**7236002  
Repairs to BEQ 4310**

**MCAS Cherry Point, NC  
AMENDMENT #0002**

Amendment 0002 is being issued to respond to pre-award RFI.

RFI Responses:

NAVFAC DRAWING NO. 12866247

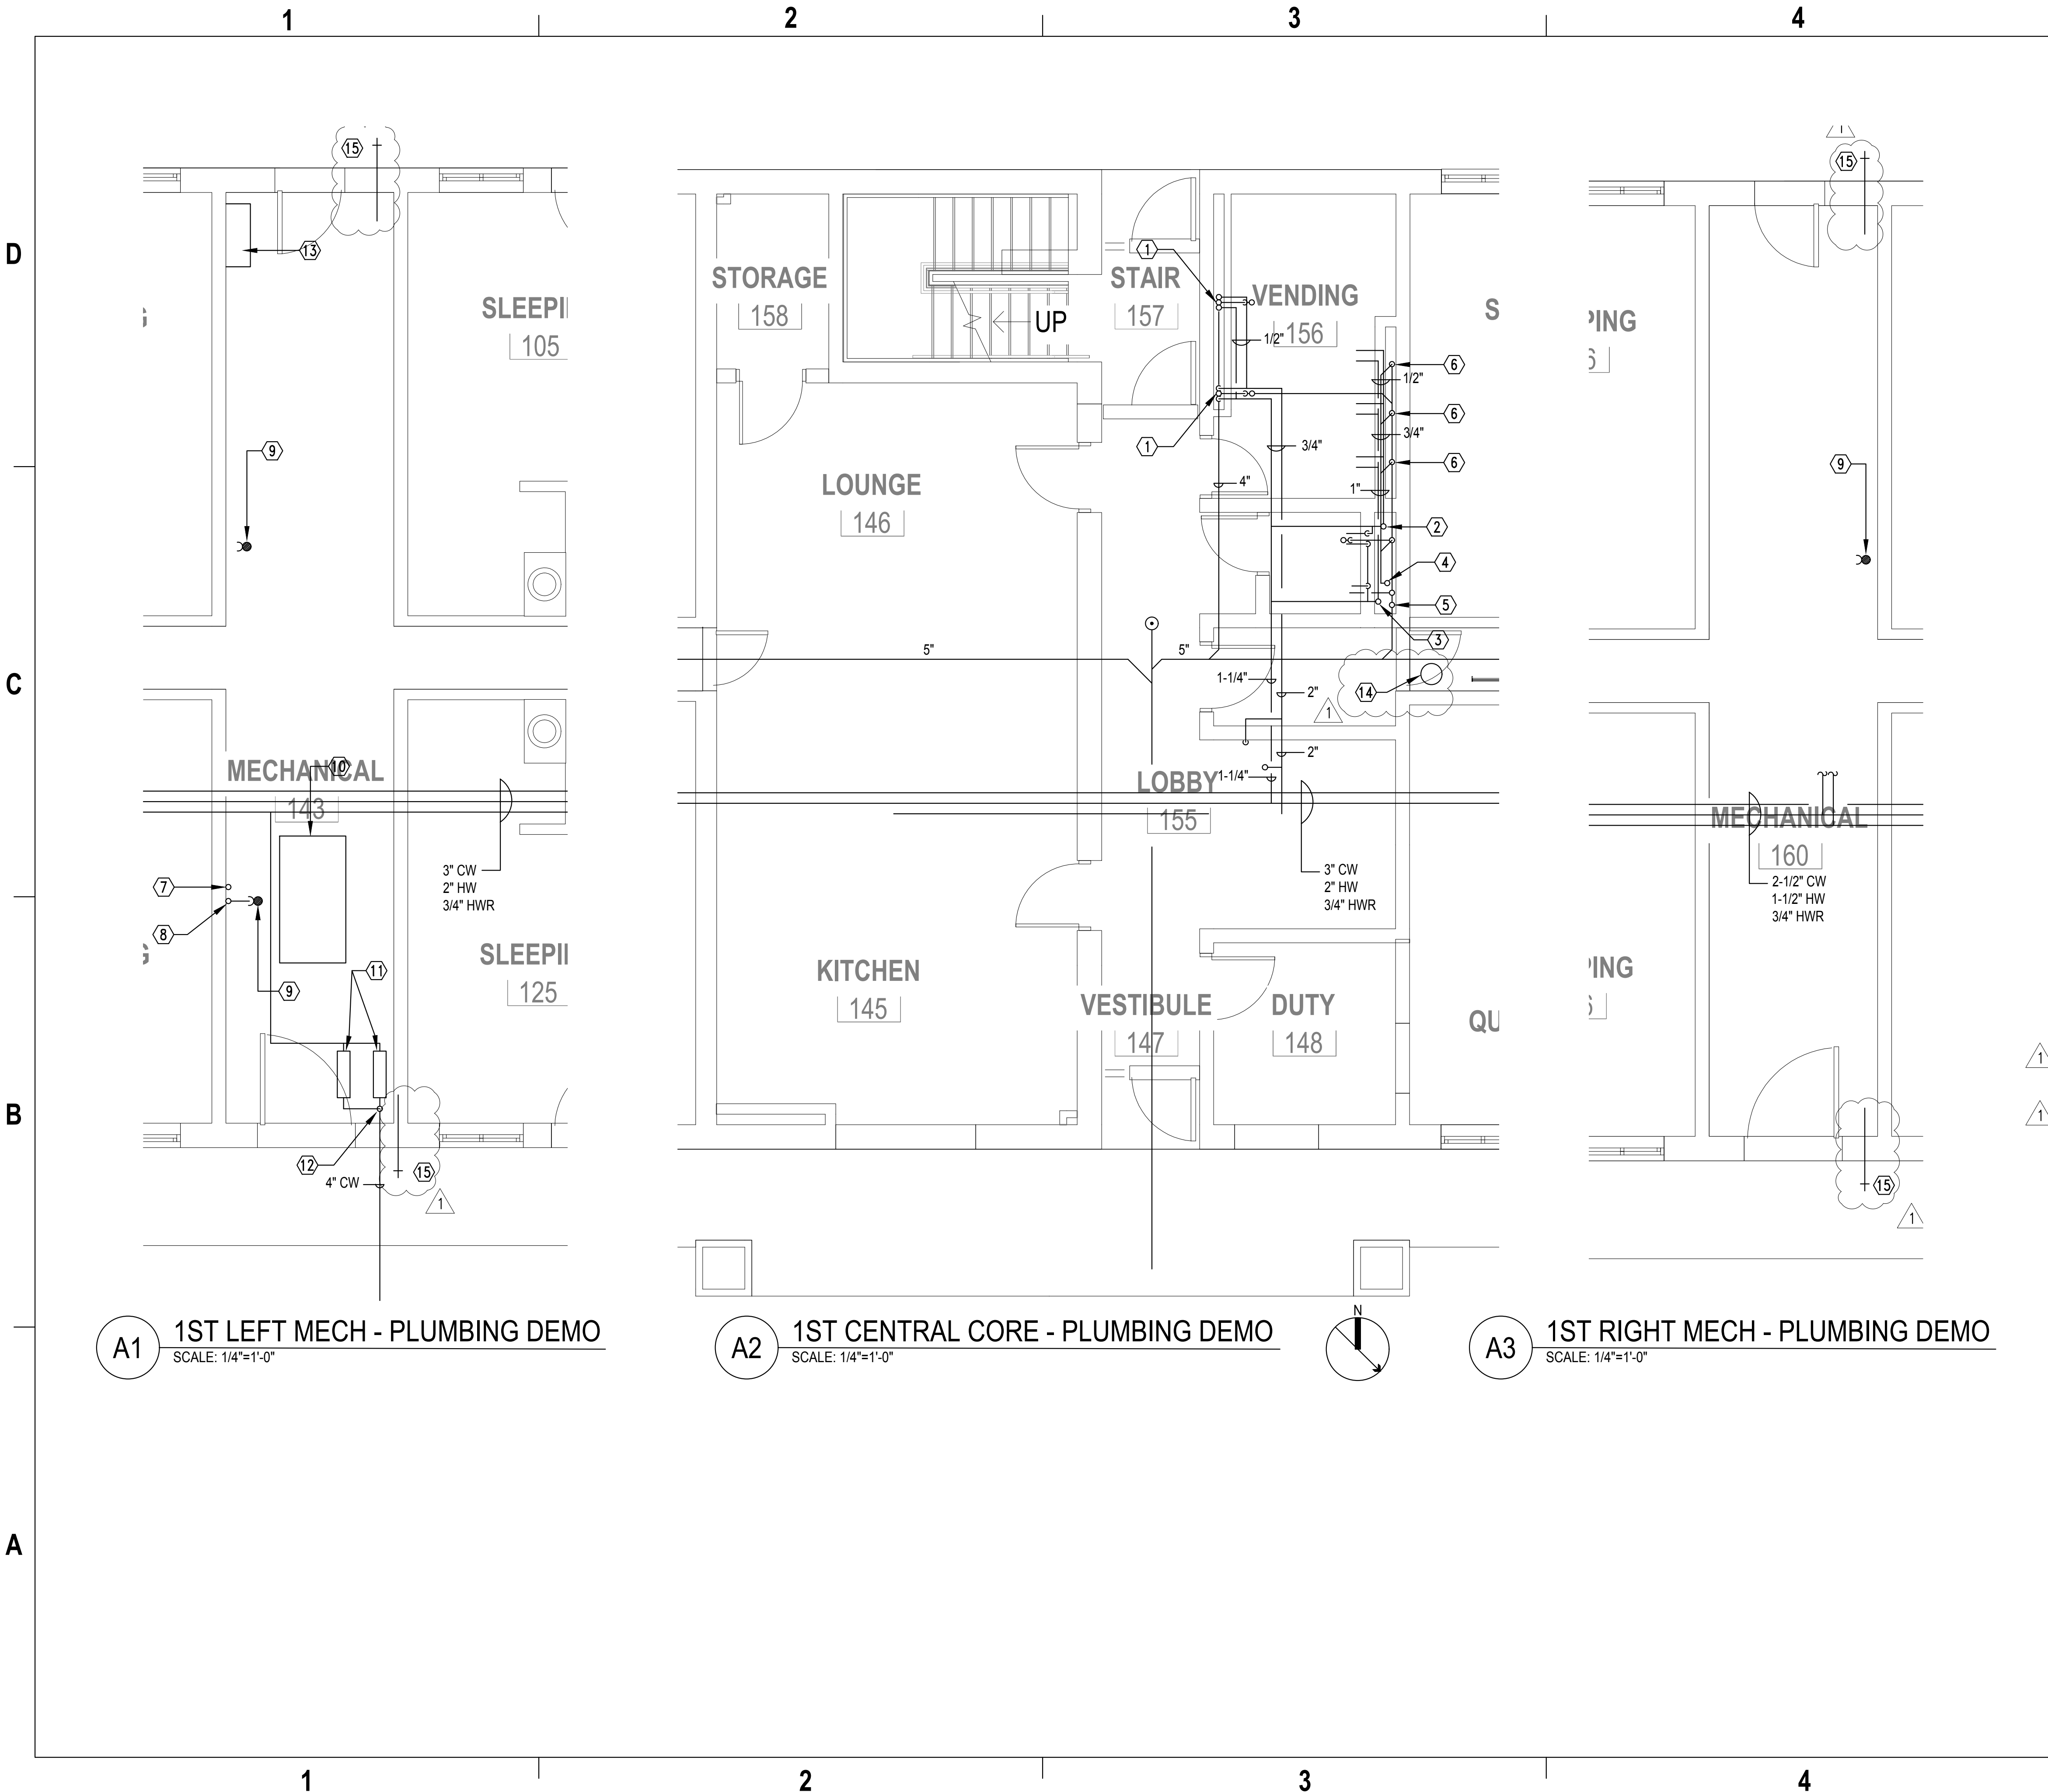
1. I noticed there is an existing sump pump located on the 1<sup>st</sup> floor within the corridor area that is not shown within the drawings to be demolished or replaced. The sump pump I am referring to is not associated with the steam pit. Is this sump pump to be removed/replaced? If so, may we get this sump pump added to the drawings, plumbing schedule, and specifications if it is to be different than what is already listed in the bid documents so that all bidders are aware of removal/replacement?

2. I do not see any exterior wall hydrants shown within the plumbing drawings, typically these BEQ's have 4ea to be removed/replaced. If there will be exterior wall hydrants to be removed/replaced, may we have them added to the plumbing drawing set so that all bidders are aware of removal/replacement?

#	DESCRIPTION	DATE	APPR
1706122			
RESPONSE TO REF #2

- 1 REMOVE EXISTING 3/4" CW & HW RISER & 3" WASTE AND 2" VENT STACK IN THIS AREA.
- 2 REMOVE EXISTING 1-1/4" HW RISER.
- 3 REMOVE EXISTING 2" CW RISER.
- 4 REMOVE EXISTING 4" VENT RISER.
- 5 REMOVE EXISTING 4" WASTE RISER.
- 6 REMOVE EXISTING WASHER BOX AND ASSOCIATED PIPING.
- 7 REMOVE EXISTING 2" VENT.
- 8 REMOVE EXISTING 3" WASTE RISER.
- 9 REMOVE EXISTING FLOOR DRAIN.
- 10 REMOVE EXISTING WATER STORAGE TANK AND ASSOCIATED PIPING.
- 11 REMOVE EXISTING BACKFLOW PREVENTERS. THEY ARE MOUNTED ON TOP OF EACH OTHER. SHOWN THIS WAY FOR CLARITY.
- 12 REMOVE EXISTING PRESSURE REDUCING VALVE AND CW SHUTOFF VALVE.
- 13 REMOVE EXISTING SUMP PUMP AND ASSOCIATED PIPING FROM STEAM PIT.
- 14 REMOVE EXISTING SUMP PUMP AND ASSOCIATED PIPING FROM CRAWL SPACE.
- 15 REMOVE EXISTING FPWH AND ASSOCIATED PIPING.

*Response: The sump pump spec will be the same as the one shown on the plans and details for the steam pit. It shall be removed and replaced. See drawings 12866247 and 1286652 revised 17 October 2022 that show the sump pump in question. Submit proposals in accordance with RFP, Specifications, Drawings and all amendments.*

*Response: See 12866247 and 12866251 revised 17 October 2022 for FPWH (freeze proof wall hydrant) locations. Submit proposals in accordance with RFP, Specifications, Drawings and all amendments.*

NAVFAC DRAWING NO. 12866251

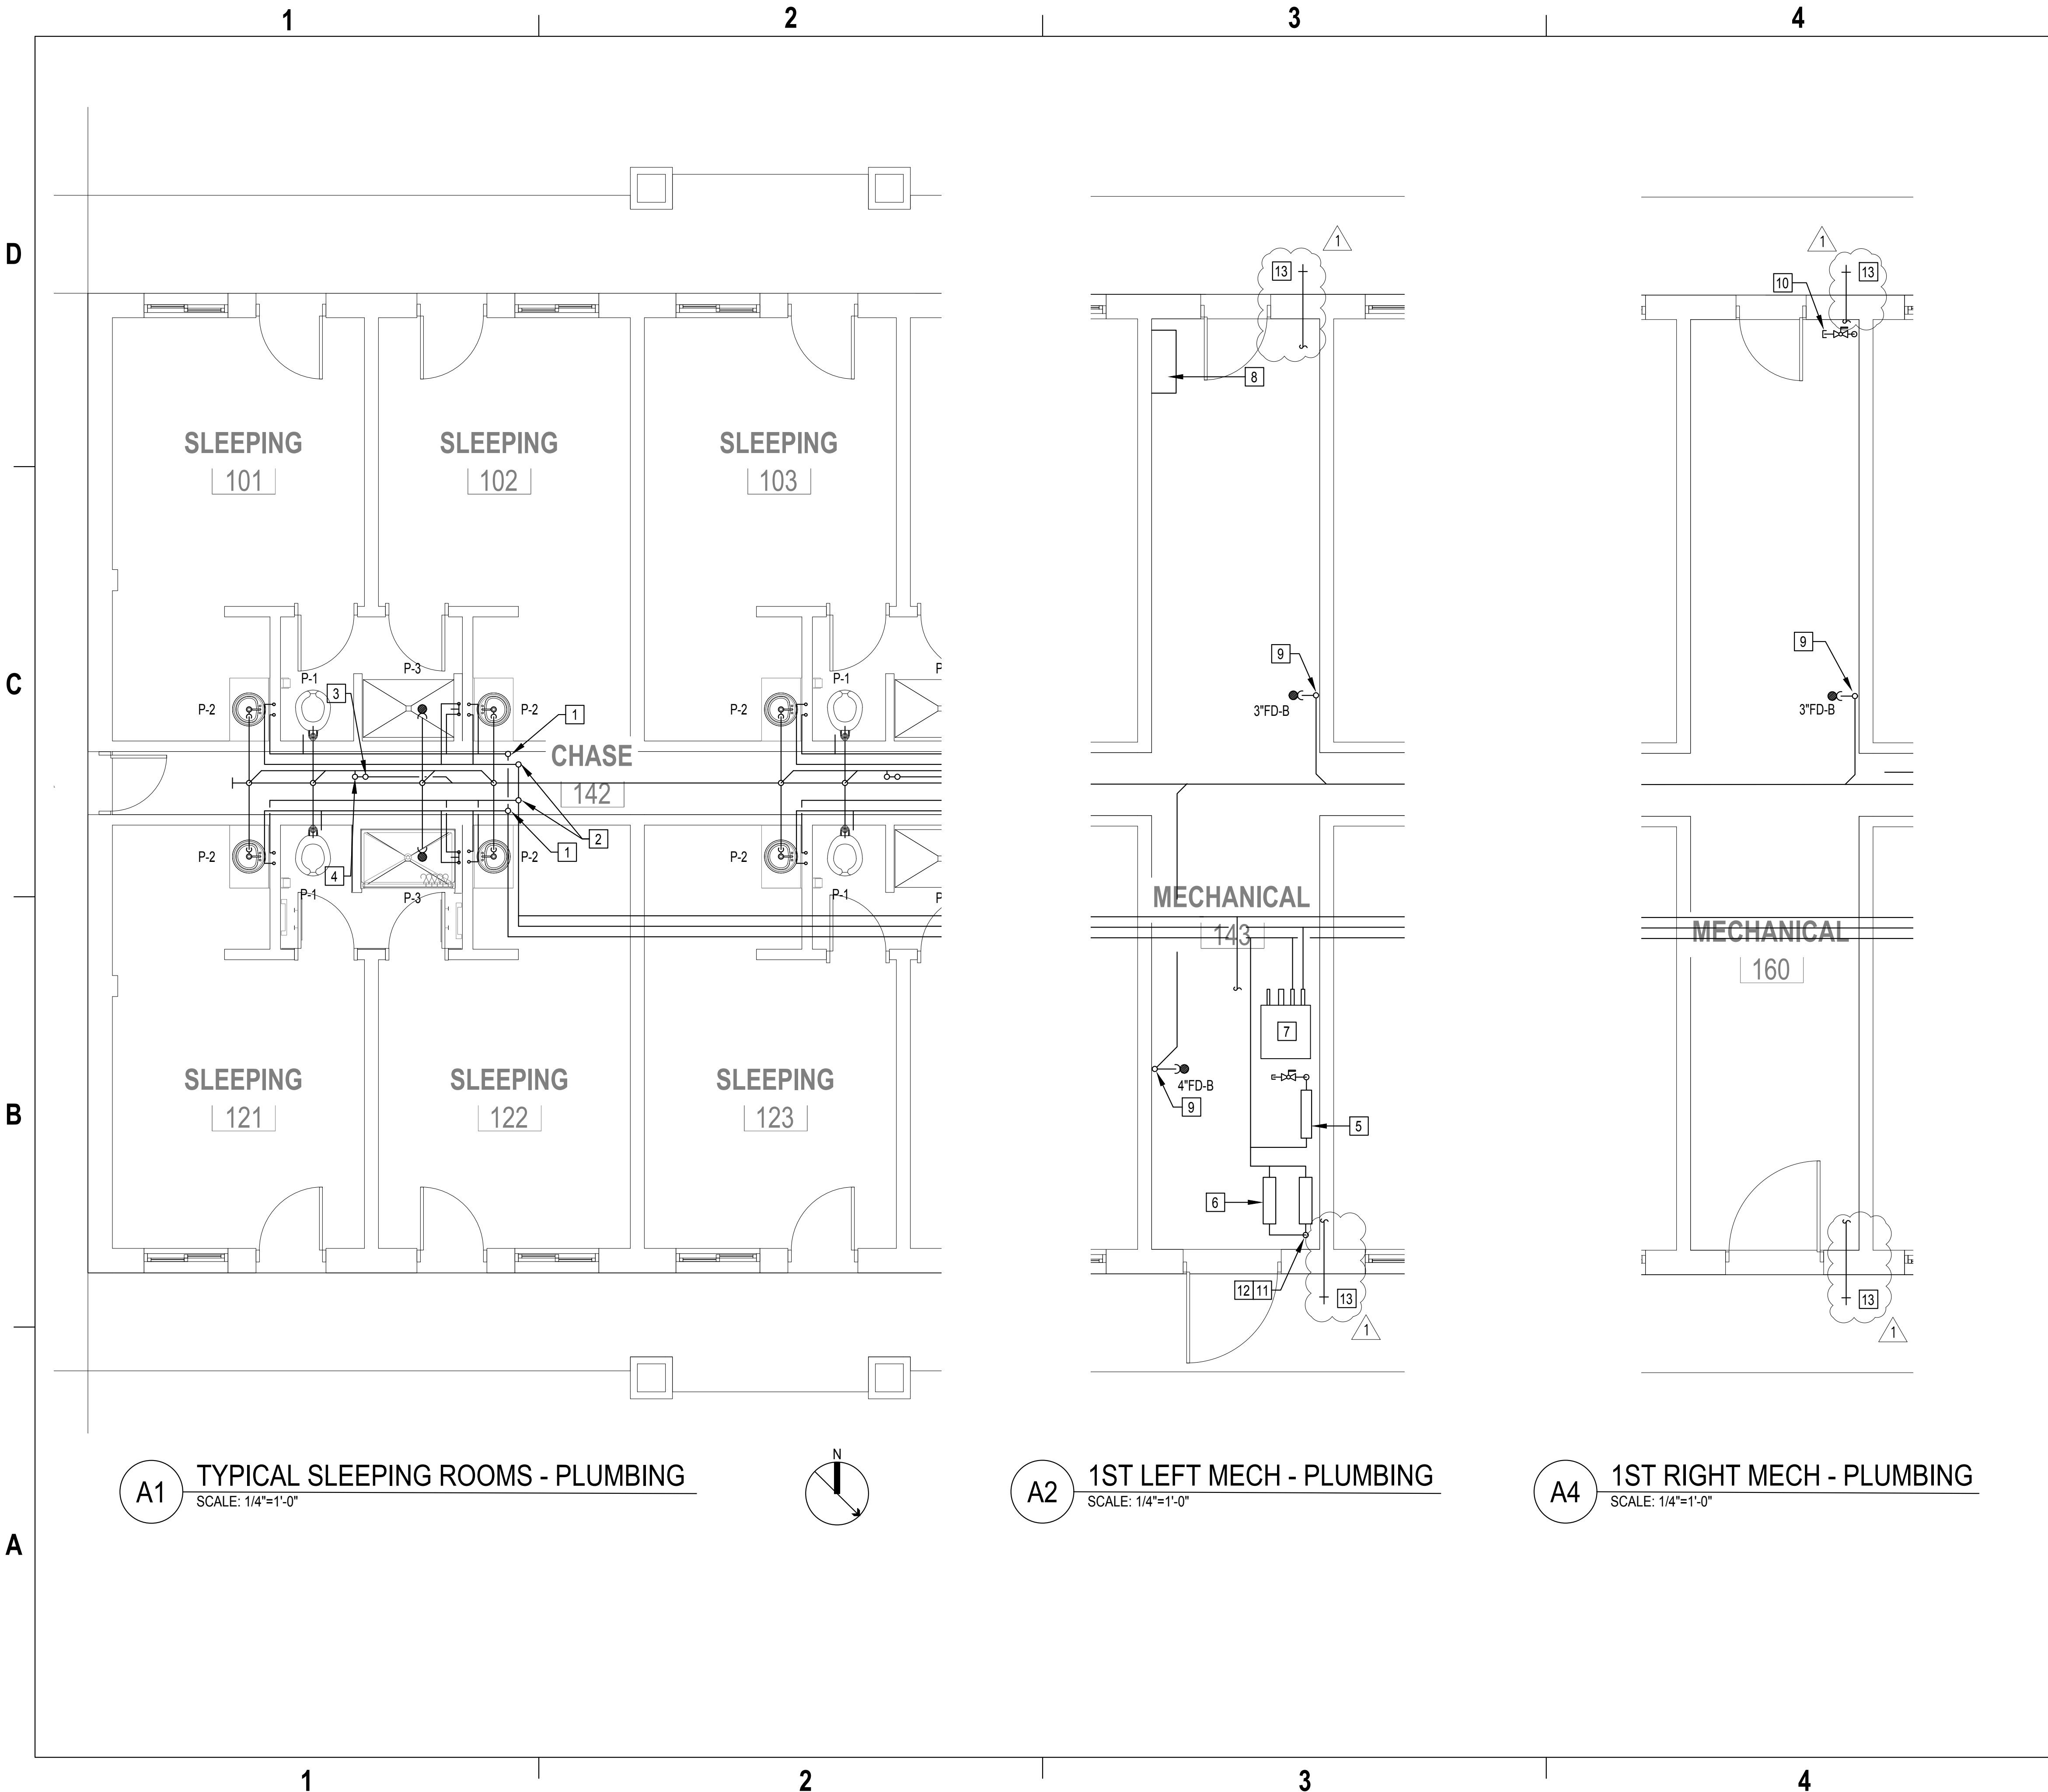
RESPONSE TO RF# 12

NEW FPWH.
